AGENDA
DANIA BEACH CITY COMMISSION
REGULAR MEETING
TUESDAY, MARCH 14, 2017 - 7:00 PM

A RESOLUTION OF THE CITY COMMISSION OF THE CITY OF DANIA BEACH, FLORIDA, APPROVING THE SITE PLAN (SP-122-16) SUBMITTED BY BK STERLING INVESTMENT, LLC FOR PROPERTY LOCATED AT 1800 STIRLING ROAD WITHIN THE CITY OF DANIA BEACH, FLORIDA, AS LEGALLY DESCRIBED IN EXHIBIT “A”; PROVIDING FOR CONFLICTS; FURTHER, PROVIDING FOR AN EFFECTIVE DATE.

SHEET NUMBER
C-300

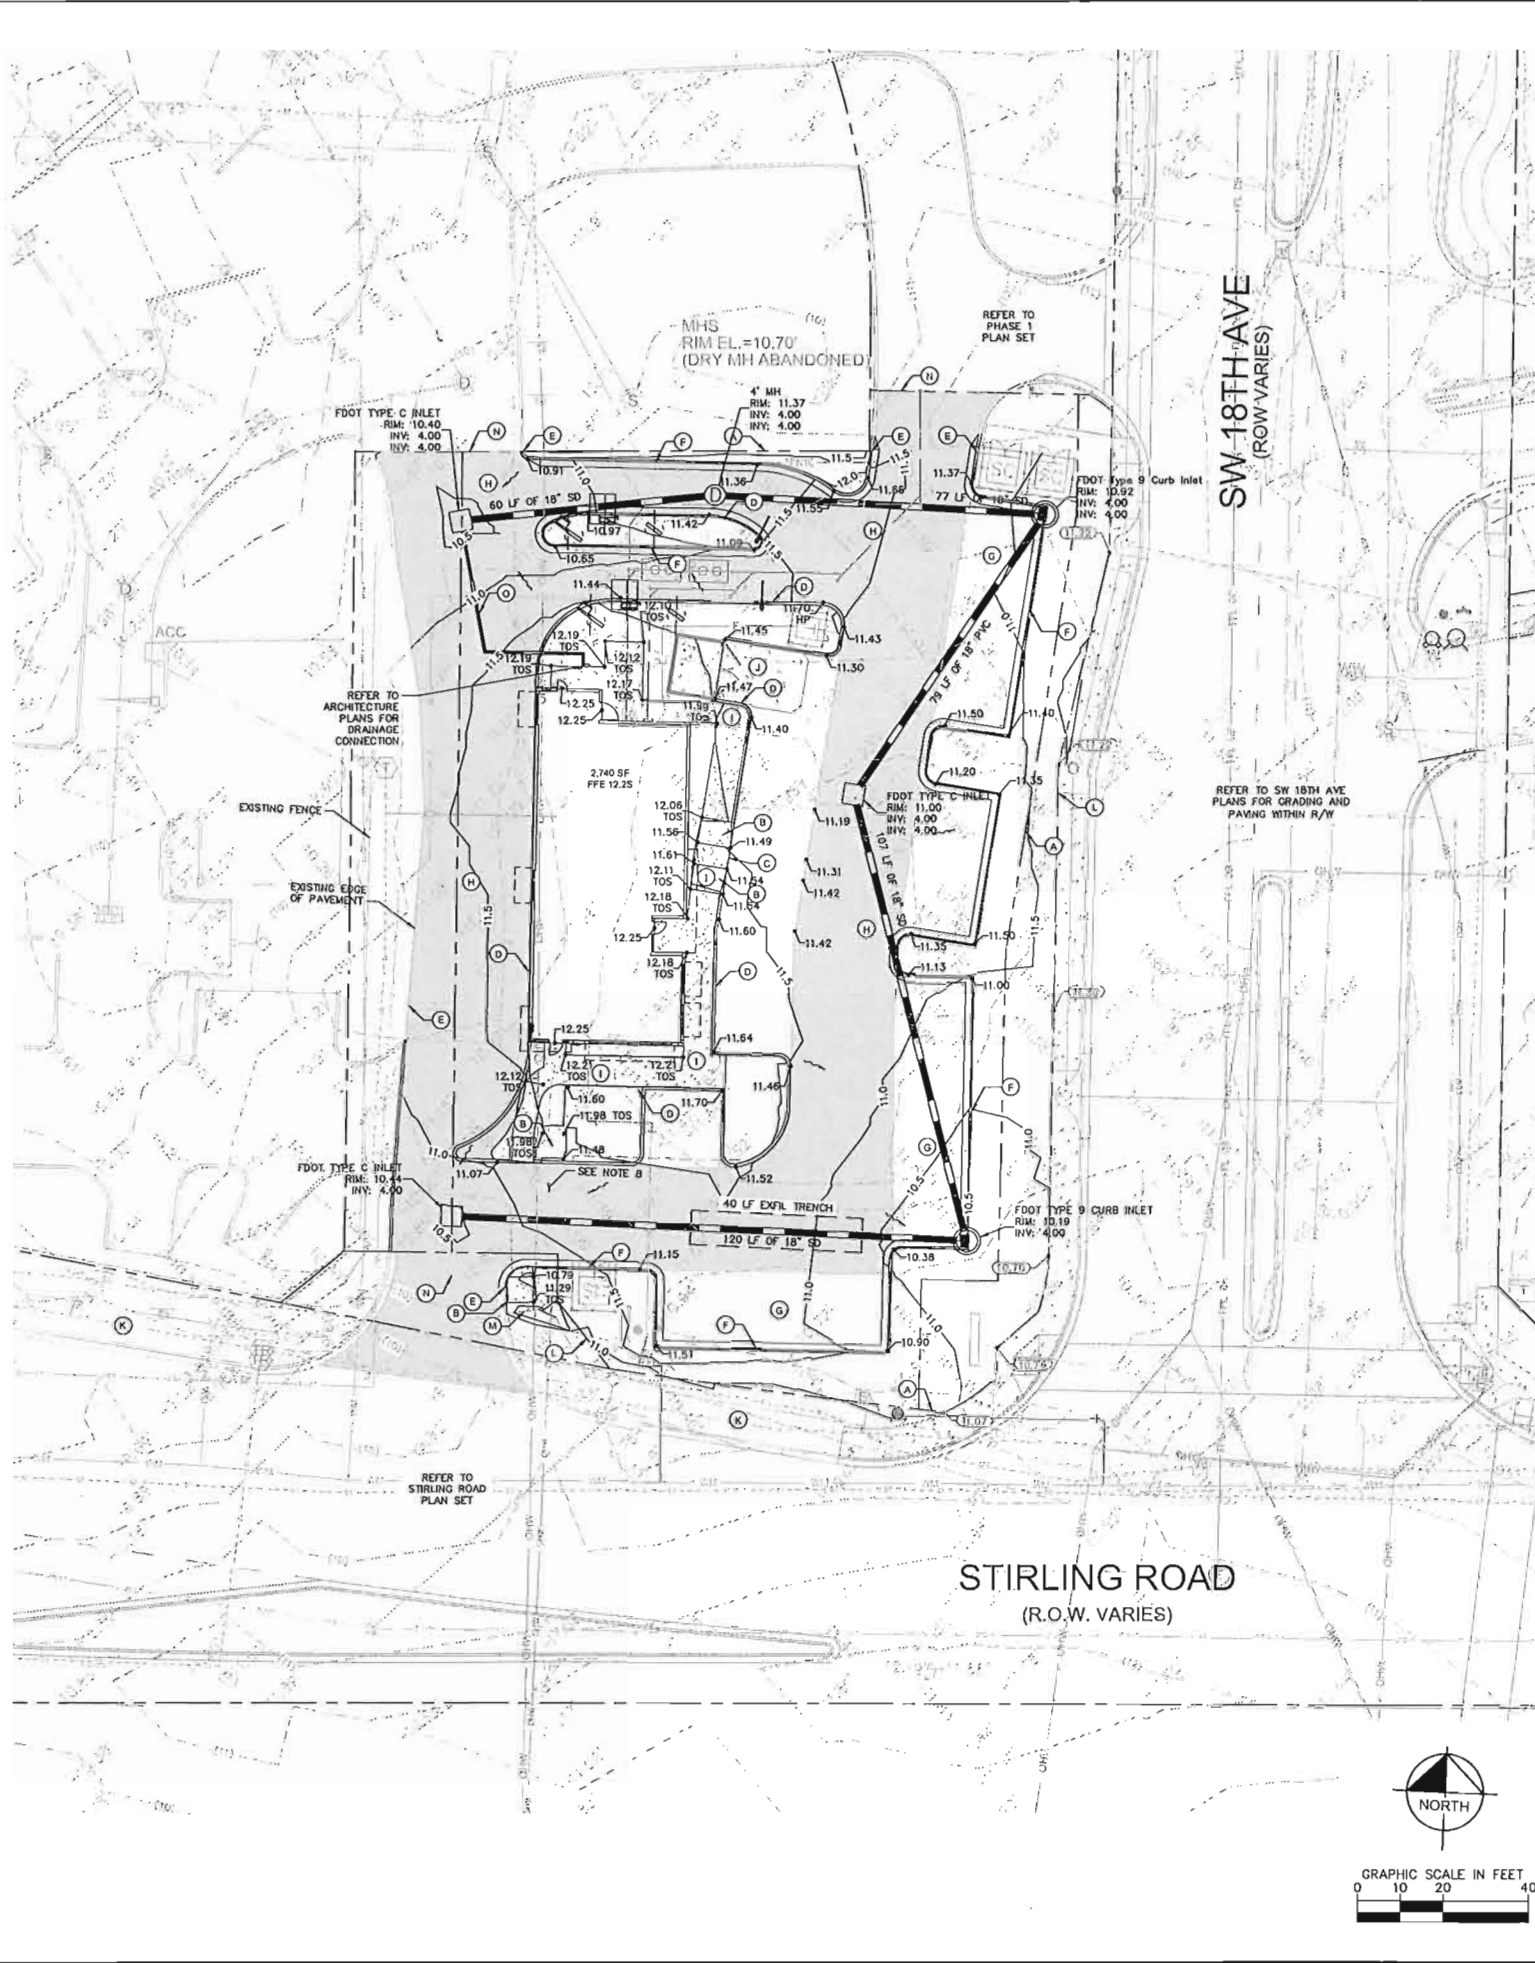
Comment 15) Sheet C-300 delete reference to Dania Pointe Project sign at the SEC as it does not relate to this site plan and is outside the property lines of the subject property.

Comment 16) Per DDG, Section 7 #7, on Sheet C-300, provide dimensions of all drive aisles and access points.

Comment 17) Sheet C-300, property line shown on survey is not the same as property line shown on site plan. If new property lines are proposed, show both (new and proposed) on site plan.

- Response 2)** *Please see updated Site Plan, Sheet C-300 reflecting a perpendicular pedestrian crossing. A stop sign and bar is located 4' prior to the cross walk.*

- Response 3)** *The two drive-thru aisles merge into one drive-thru aisle at the payment and pick-up window. Once the driver exits the pick-up window, the drive-thru aisle merges with the southbound bypass lane at the stop bar just south of the Burger King. A callout has been added to the stripe designating the separation between the two lanes. Please see attached Site Plan, Sheet C-300.*

Response 15) *Acknowledged. Sheet C-300 has been updated to reflect this change.*

Response 16) *Please see updated Site Plan, Sheet C-300, showing dimensions of onsite driveways and offsite driveways to the centerline.*
